SEMINOLE COUNTY GOVERNMENT
1101 EAST FIRST STREET, 2ND FLOOR, WEST WING
SANFORD, FLORIDA 32771

PROJECT NAME:	W CRYSTAL DR - PRE-APPLICATION	PROJ #:
APPLICATION FOR:	DR - PRE-APPLICATION DRC	24-80000027
APPLICATION DATE:	2/27/24	
RELATED NAMES:	EP BRENDA PEARCE	
PROJECT MANAGER:	KATHY HAMMEL (407) 665-7389	
PARCEL ID NO.:	04-20-30-300-0010-0000	
PROJECT DESCRIPTION	PROPOSED SPECIAL EXCEPTION FOR A NEW WATER METER SYSTEM ON 0.08 ACRES IN THE R-1A ZONING DISTRICT LOCATED ON THE NORTH SIDE OF W CRYSTAL DR, EAST OF COUNTRY CLUB RD	
NO OF ACRES	0.08	
BCC DISTRICT	4: LOCKHART	
CURRENT ZONING	R-1A	
LOCATION	ON THE NORTH SIDE OF W CRYSTAL DR, EAST OF COUNTRY CLUB RD	
FUTURE LAND USE-	LDR	
APPLICANT:	CONSULTANT:	
BRENDA PEARCE BLACK & VEATCH/SUNSHINE WATER 200 WEATHERSFIELD AVE ALTAMONTE SPRINGS FL 32714 (678) 656-5179 PEARCEB@BV.COM	N/A

PROJECT AREA ZONING AND AERIAL MAPS

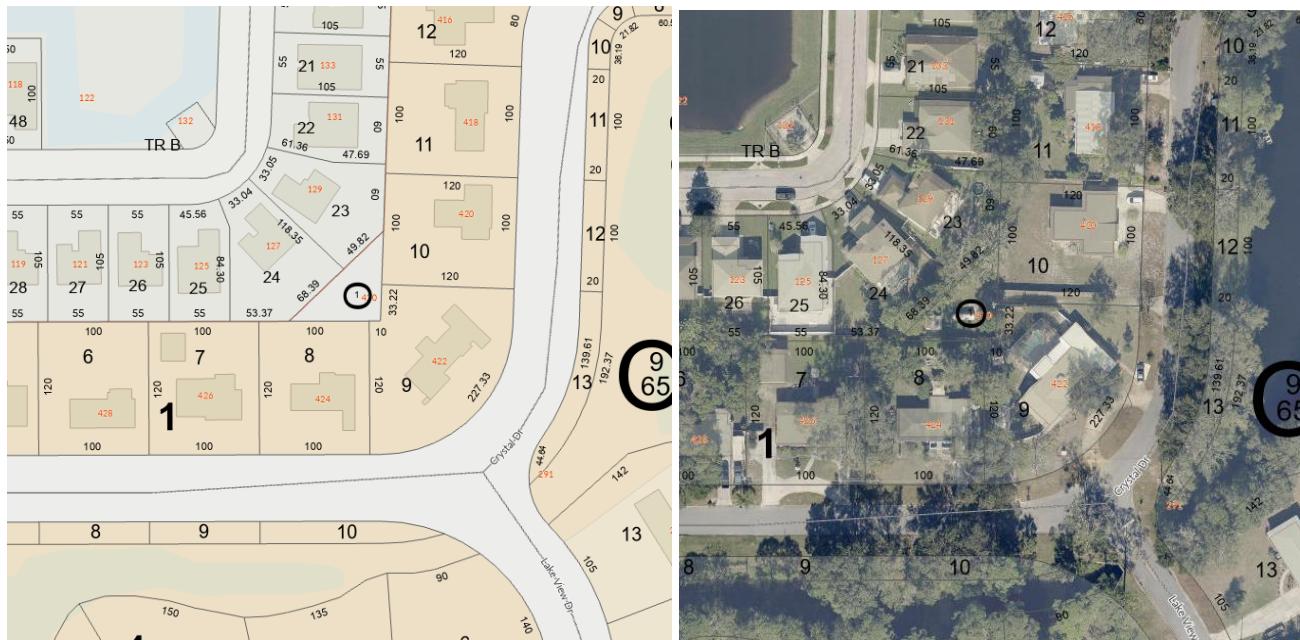
The parcel located within unincorporated Seminole County have a zoning classification of R-1A (Single Family Residential).

The installation of a pole with an antenna for a new water metering system will require a Special Exception to allow the use in the applicable zoning district. A variance to the building/structure height of 35 feet may also be required.
